YUROK TRIBE

May 26, 2010

OREGON DRAFT KLAMATH RIVER TMDL COMMENTS

Figure 1. Historic size of Lower Klamath Lake and associated wetlands are shown in the map above, with wetlands broken down by percentage of cover by bulrushes. Note extensive marsh areas surrounding the Klamath River at upper left. Map from USBR (2005).

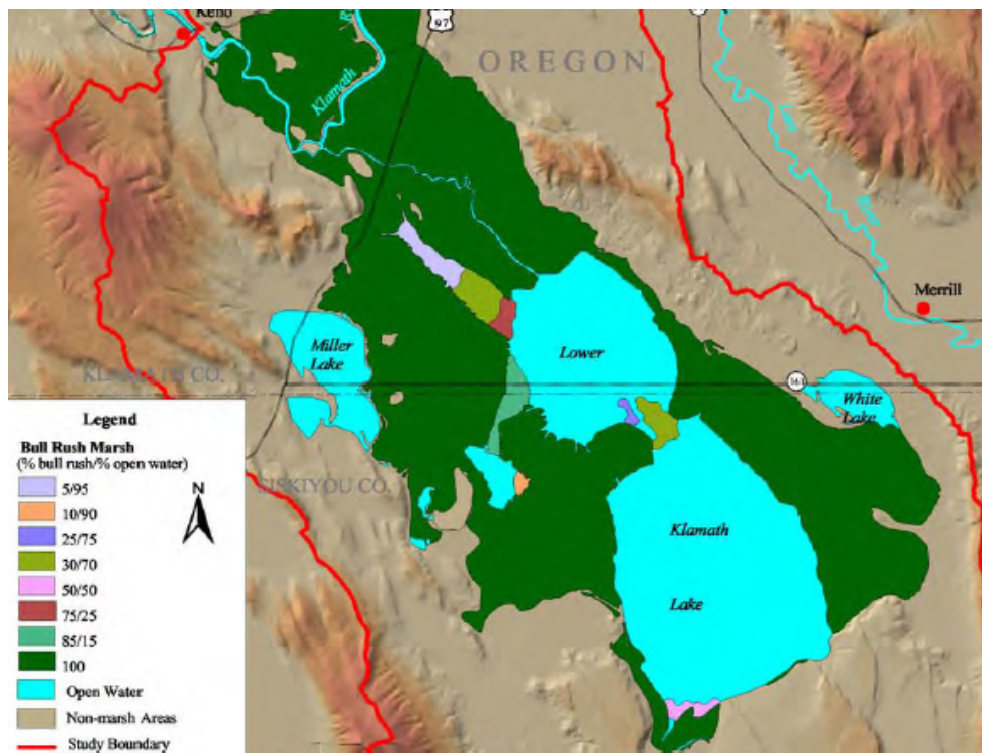
The Klamath River in what is now the Keno Reservoir reach was once surrounded by thousands of acres of wetlands (Figure 1) that supplied natural water filtration, water storage, and hyporheic connections that promoted river cooling. The Klamath River in Keno Reservoir is now almost completely channelized and confined. Channelized rivers have lower rates of nutrient attenuation (Bernot and Dodds 2005, Yurok Tribe 2007).

Figure 2. This image in the Klamath River in the Keno Reservoir reach is captured from Google Earth.

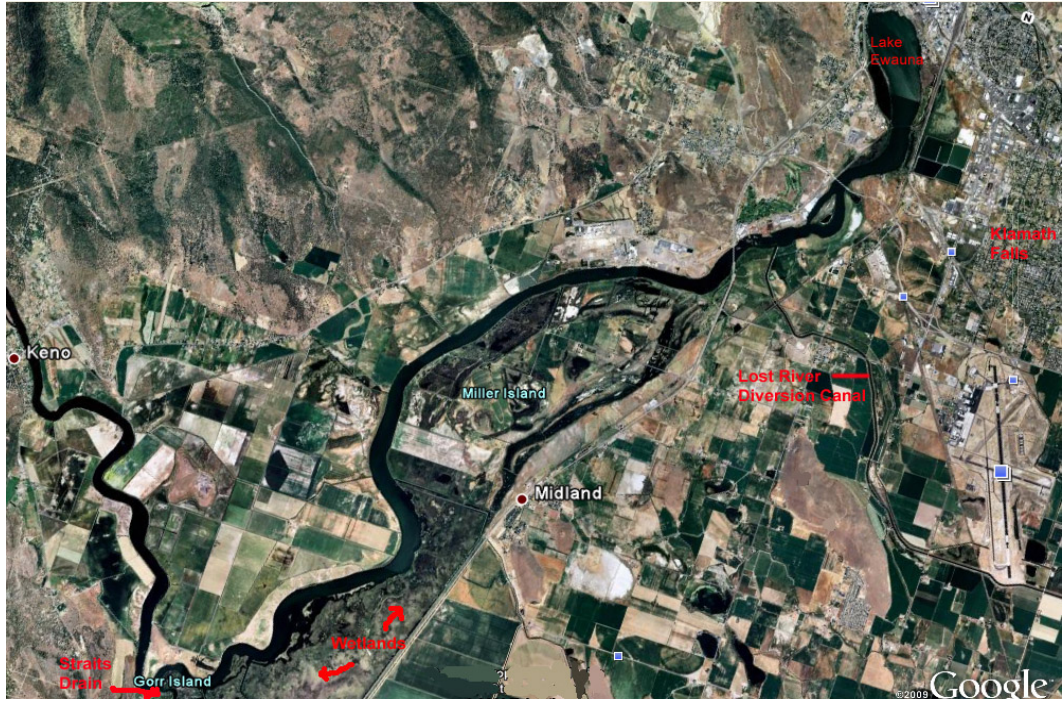
A functional riparian buffer needs to be restored adjacent to the river in addition to constructed wetlands (see below). As noted in Yurok (2007) and Karuk (2007) comments on the Lost River TMDL, marsh buffers could promote mildly acidic conditions, potentially retarding the growth of the bluegreen algal species *Aphanizomenon flos-aquae* that washes out of Upper Klamath Lake and can further proliferate and add to nutrient enrichment in Keno Reservoir. Figure 2 shows the Keno Reservoir reach with remnants of natural marsh areas, but mostly agricultural development with no riparian buffer strip.

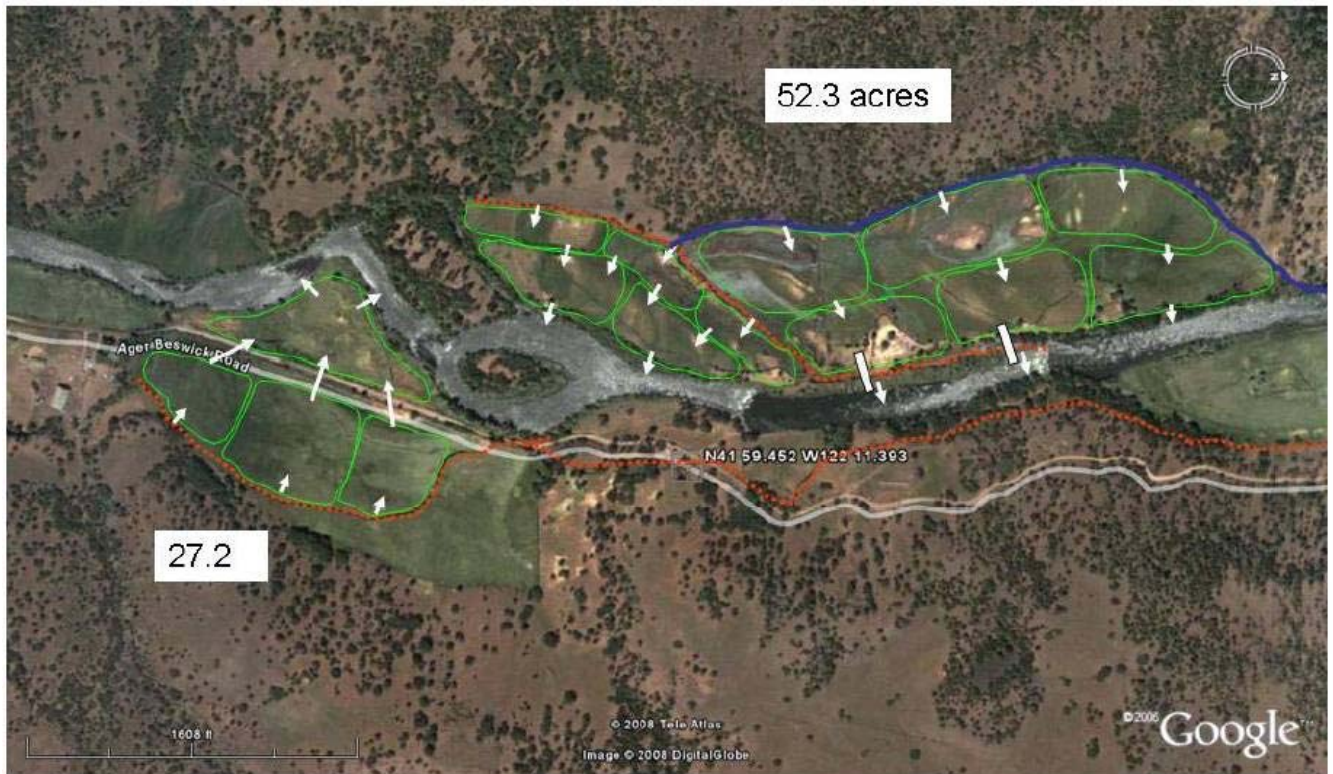
We recommend treatment wetlands with different types of characteristics depending upon their location along the Klamath River. These wetlands should be optimized to remove the specific forms of nutrients or organic matter that are abundant at a particular location.

Deas and Vaughn (2006) did literature research and calculations to investigate the potential of wetlands to remove particulate organic matter between Link Dam and Keno Dam. Their estimated scale for significantly reducing nutrients was 1,400 acres. A 5,000-acre marsh was thought sufficient to filter the entire upper Klamath River flow. However, they recommended that a pilot scale project be constructed to test effectiveness before large scale construction is considered. Mahugh et al. (2008) inventoried potential sites around Keno Reservoir for possible placement of pilot and full-scale treatment wetlands, and modeled potential effectiveness of such wetlands, and that team has submitted a proposal to USBR to construct a pilot project, but we are unclear whether the project has been funded. Lyon et. al (2009) conducted a similar study, but in addition to Keno Reservoir, also included areas between Keno and Iron Gate Dams see figure 3.

Figure 5. Oblique aerial photograph of Oregon forests, looking north from J.C. Boyle Reservoir. The dotted blue line shows approximate path of lower Spencer Creek. Image from Google Earth.

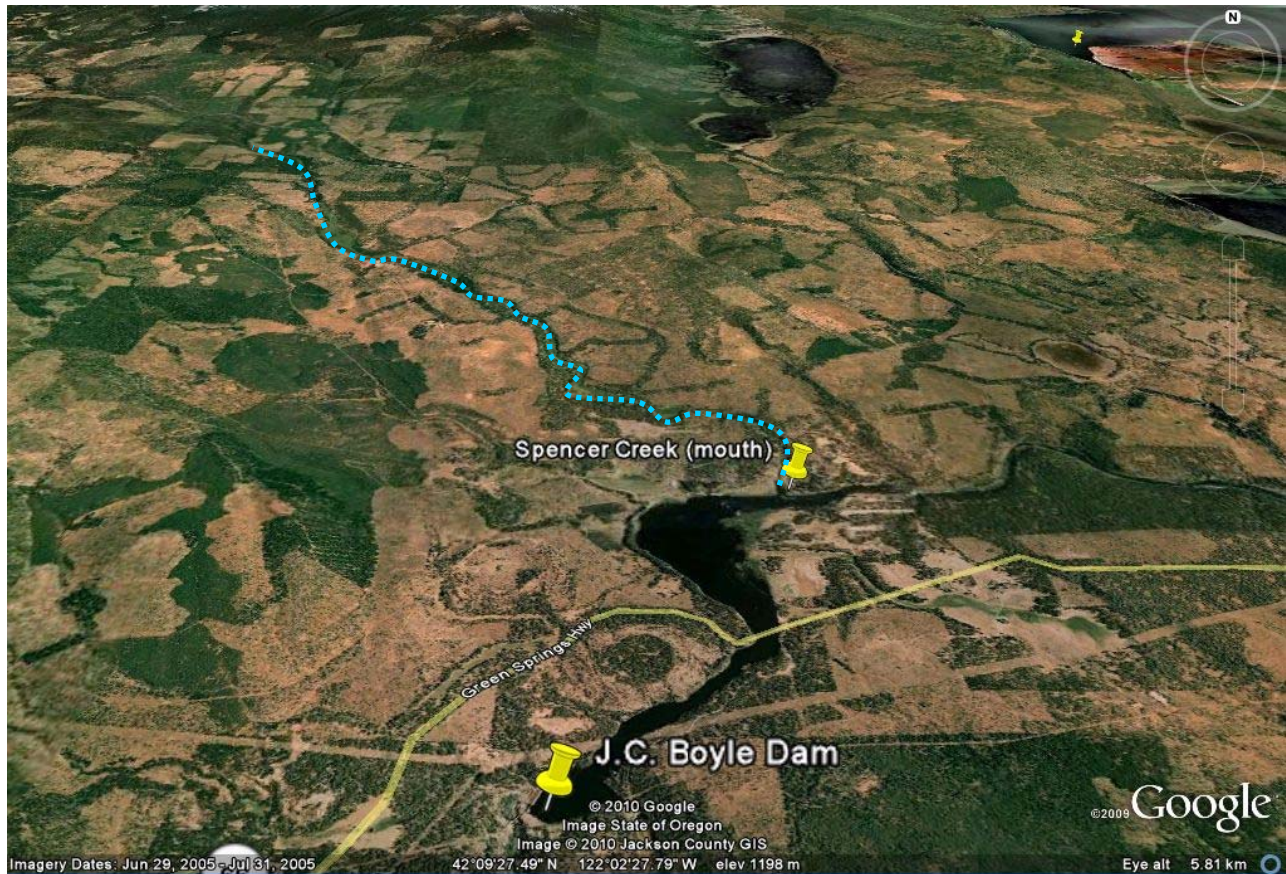
The water quality effects of timber harvest and roads on private lands are an important issue generally in the Klamath River Basin, but play a particularly critical role in the impairment of coldwater tributaries. For example, Spencer Creek is a Klamath River tributary that currently drains into J.C. Boyle reservoir. It contains low-gradient stream habitat that is rare in tributaries of the Middle/Upper Klamath Basin. Following the likely removal of J.C. Boyle, Copco, and Iron Gate dams, a restored Spencer Creek could provide excellent habitat for coho salmon. The *Draft TMDL and WQMP Plan* found that current riparian shade is 60% lower than the estimated maximum potential, current water temperatures at the mouth of Spencer Creek are 10 °C warmer than its natural thermal potential (Figure 4), and that a substantial portion of this water warming is due to the lack of vegetative shade. Examination of aerial photographs of the Spencer Creek watershed and the surrounding areas shows more bare ground than trees, with the forest confined to narrow strips (Figure 5), a powerful illustration of the poor condition of private timber lands in the Oregon portion of the Klamath River Basin.

The *Draft TMDL and WQMP* relies on the Oregon Department of Forestry's ongoing implementation of Oregon's Forest Practices Act (FPA) to ensure that private land forestry activities do not result in water quality impairment. Unfortunately, these regulations have long been recognized as inadequate for the protection salmonid habitat and water quality. For example, the Independent Multidisciplinary Science Team (IMST 1999) was convened by the State of Oregon to assess whether the FPA rules were sufficiently protective to restore wild salmonids in Oregon. The IMST found that the existing rules were not adequate on several bases, including water quality issues such as sedimentation resulting from landslides and roads. We are not aware of any significant improvements to the Oregon FPA rules to address the shortcomings identified by the IMST. The National Marine Fisheries Service has also recognized the shortcomings of the FPA rules and has made recommendations to the State of Oregon (NMFS 1998), but these recommendations have not yet been implemented.

We realized that ODEQ's authority to resolve the situation is limited due to existing laws, regulation, and politics; however, we feel compelled to note the approach outline in the *Draft TMDL and WQMP* to address the water quality impacts of forestry on private lands is unlikely to succeed.
